**PATTON MARINE INC.**  
**SURVEYORS And CONSULTANTS**  
P.O. Box 331884  
Miami, FL 33233-1884, USA

**May 30, 2026**  
**File No.: 13984-26**  
**Page 1 of 36**

**RE: "ELYSIAN", 2004,  
130' Westport Motor Yacht**

**RECOMMENDATIONS**

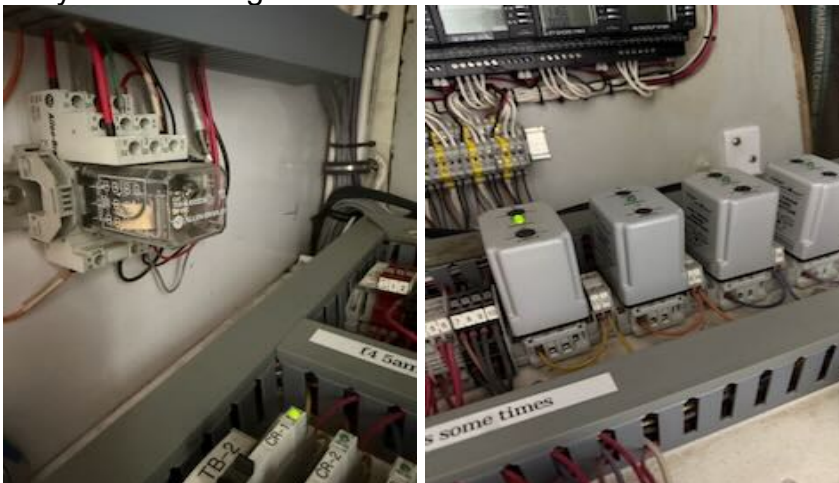
11. The shore power input selector switch is located starboard aft machinery space; the switch connections are connected using nuts and bolts then wrapped with electrical tape which is not rated for the expected current. Re-connect these connections to approved marine grade connectors.

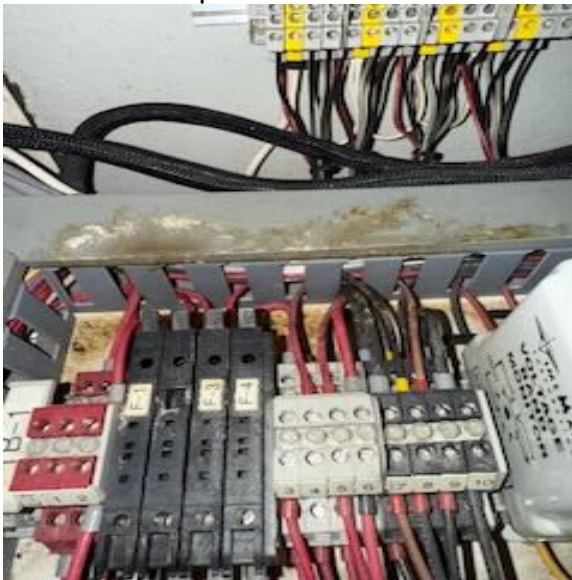
8. The lower inboard section of the main switchboard house the battery chargers, the section door houses cooling fans that are not filtered, contaminants are being drawn into the battery chargers. Service all battery chargers, clean this panel section and ad filter to the cooling fans.

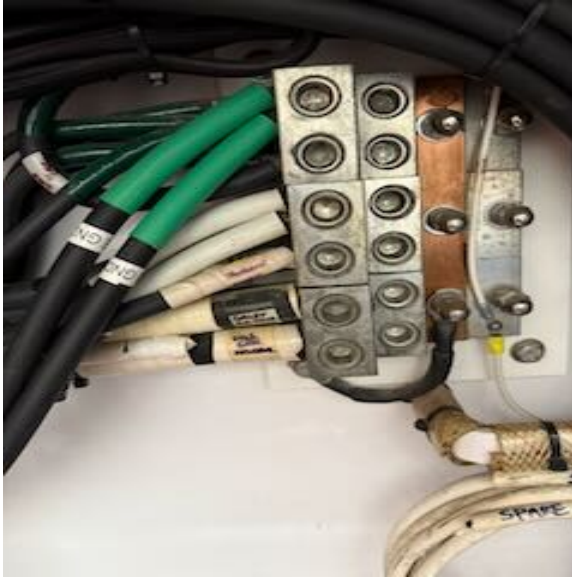
9. ★Air conditioning chilled water is leaking on to electrical components in the main switchboard inboard section. Trace and remove this leak, replace any damaged electrical components.

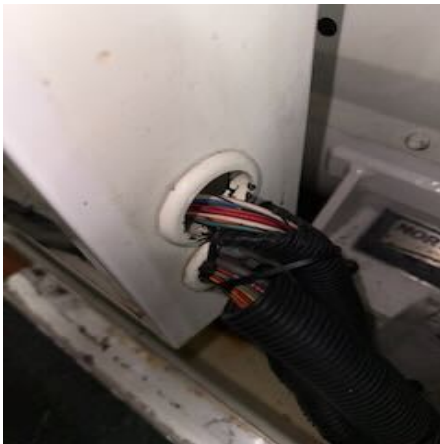
1. The generators vibration mounts are contaminated. Anticipate generator vibration mount replacements.

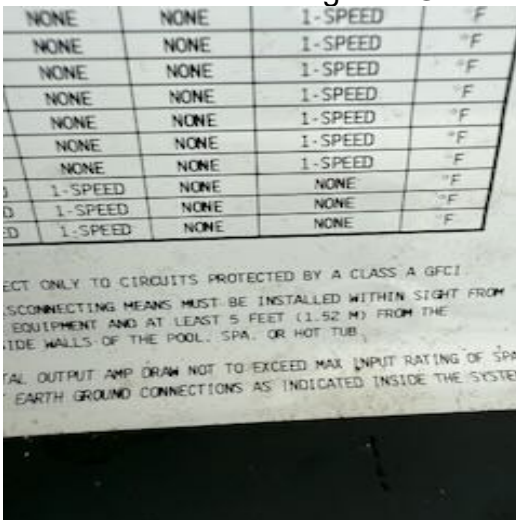
1. The engine and generators fuel filters are not fitted with catch bowls. Install fuel spill catch bowls.
2. The starboard main engine exhaust associated control relay and terminal block connection located just inboard of the shore power Glendenning cable reel are exposed. Re-connect these electrical components within a marine approved connection box.

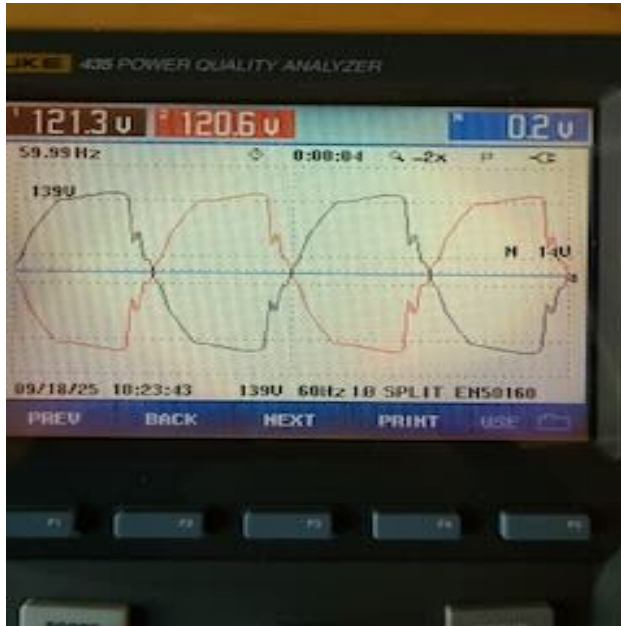
The vessels power system was connected to a Fluke power quality analyzer, test results show the harmonic distortion very high at 15.3%, which is above the acceptable level of 8%, and the voltage crest factor was very low at 1.28.

In addition, voltage wave form is heavily corrupted and is flat topping, this condition will not allow any electrical components utilizing capacitors to fully re-charge which could cause damage / failure of sensitive equipment.
